HISTORIC AND DESIGN REVIEW COMMISSION

HDRC CASE NO: 2022-577
ADDRESS: 305 LAVACA ST
LEGAL DESCRIPTION: NCB 708 BLK 8 LOT 2 ***MASTER FILE-COMMON ELEMENTS*** (305 LAVACA TOWNHOUSES)
ZONING: RM-4, H
CITY COUNCIL DIST.: 1
DISTRICT: Lavaca Historic District
APPLICANT: Tim Rodgers/South Flores Construction
OWNER: Tony Pearson/305 LAVACA TOWNHOUSES
TYPE OF WORK: New construction of two 2-story, single-family structures and one 2-story duplex structure
APPLICATION RECEIVED: March 17, 2023
60-DAY REVIEW: Not applicable due to City Council Emergency Orders
CASE MANAGER: Rachel Rettaliata
REQUEST:

The applicant is requesting conceptual approval to construct two 2-story, single-family structures and one 2-story duplex structure at 305 Lavaca.

SCALE: 1/4" = 1'-0"

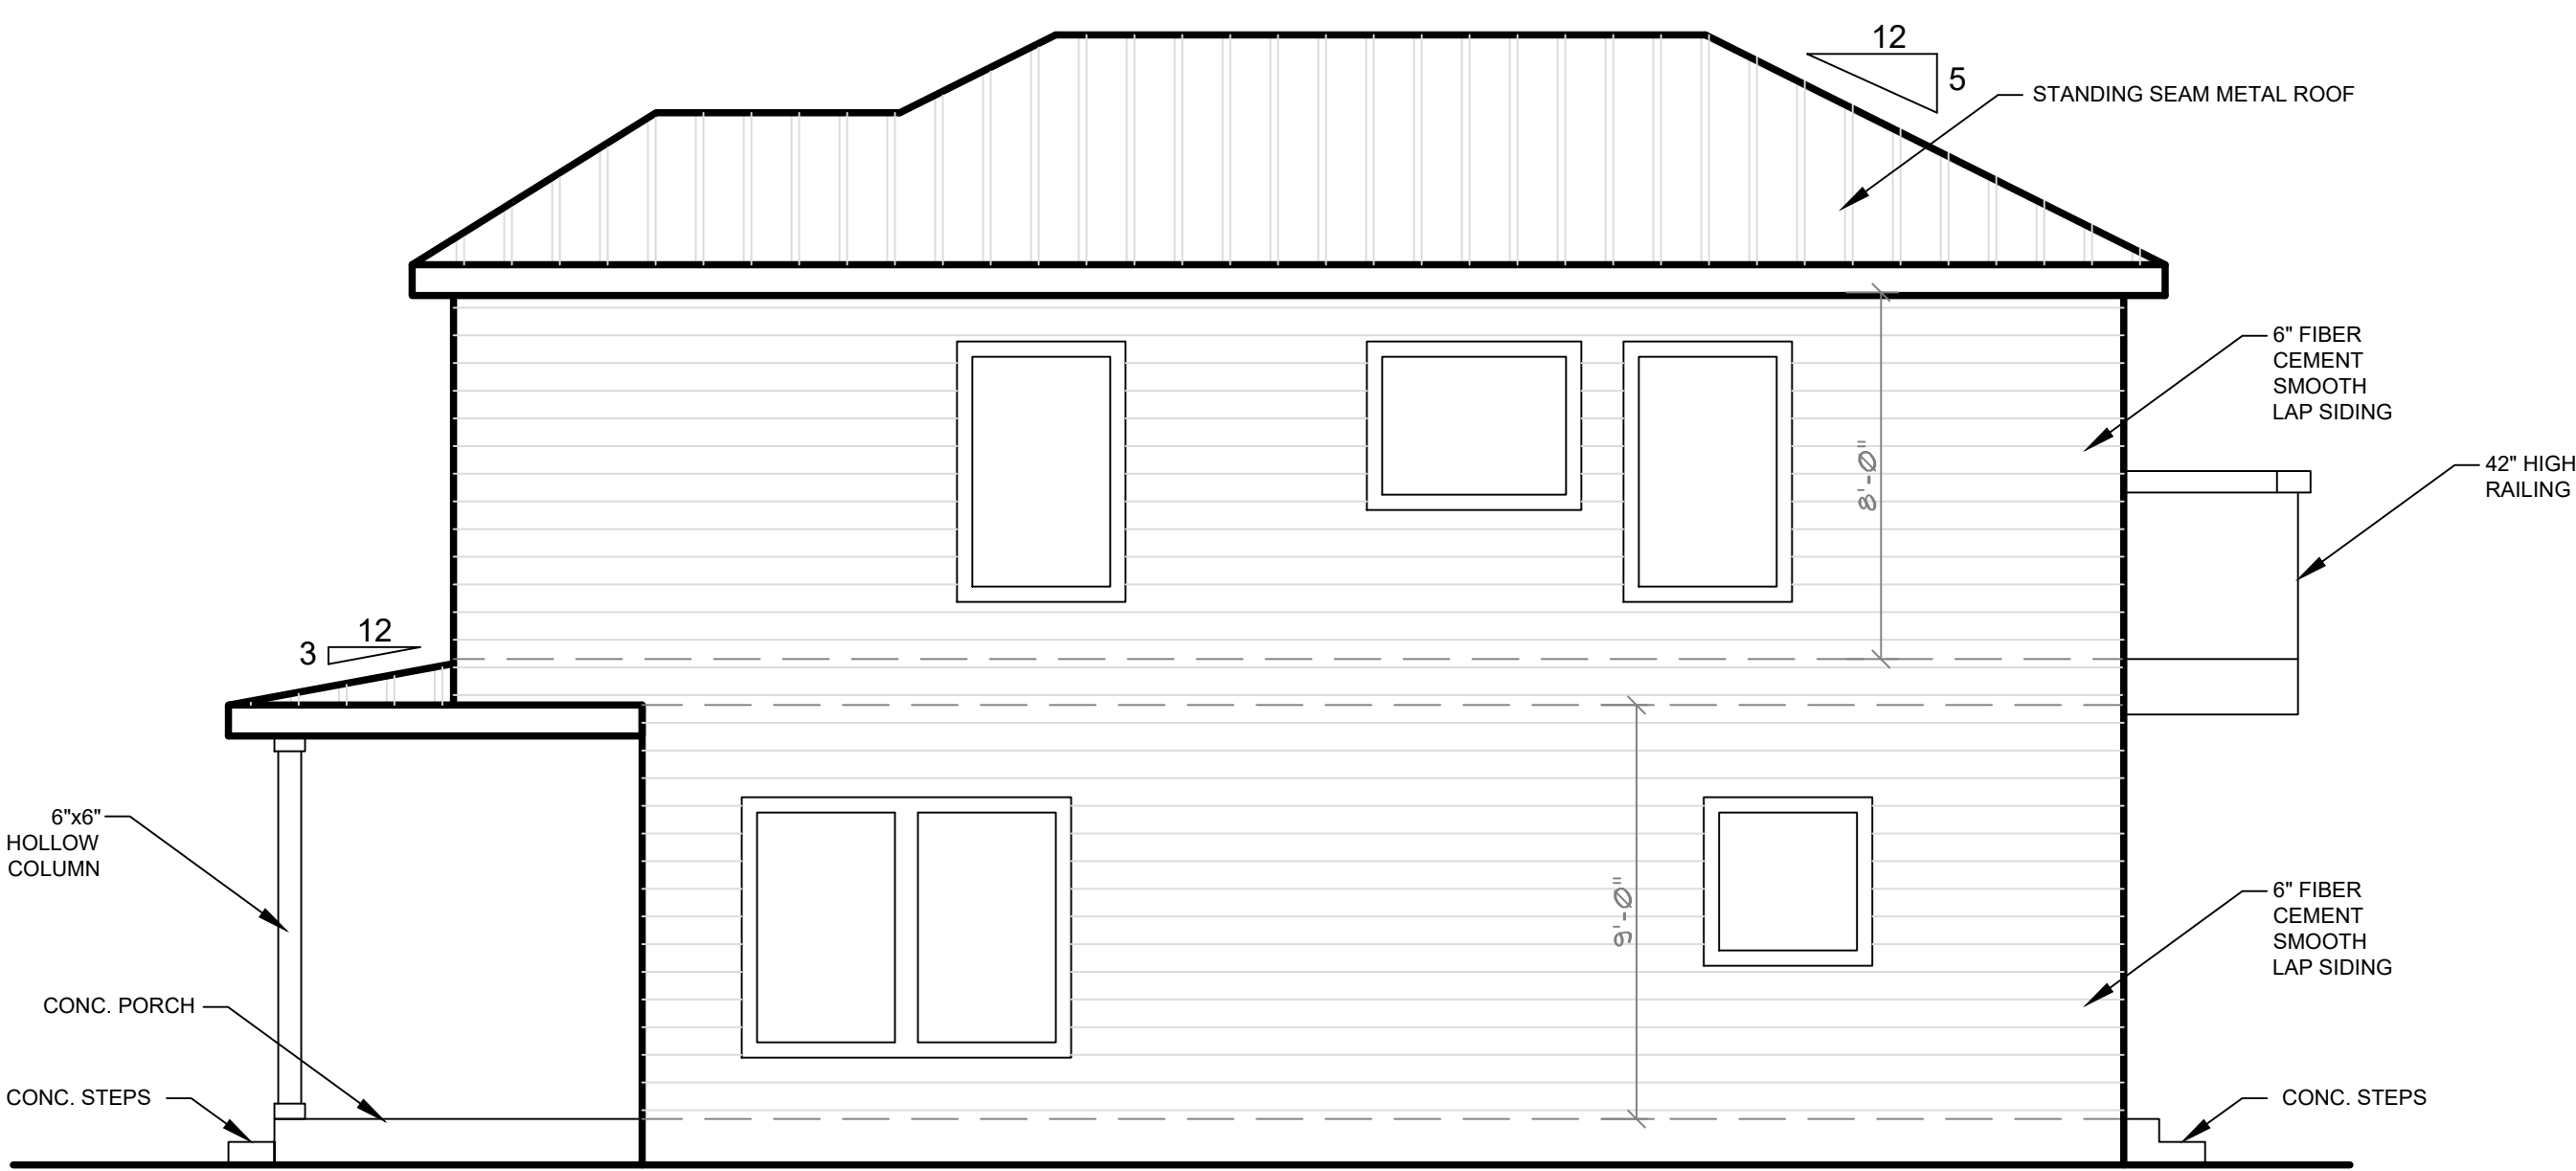
JF: I think the infill development that you provide will help to provide context. On Unit 2, I would recommend looking into more fenestration on the outside facing elevation. Staff can help you with window details regarding true vs faux divided lites etc.
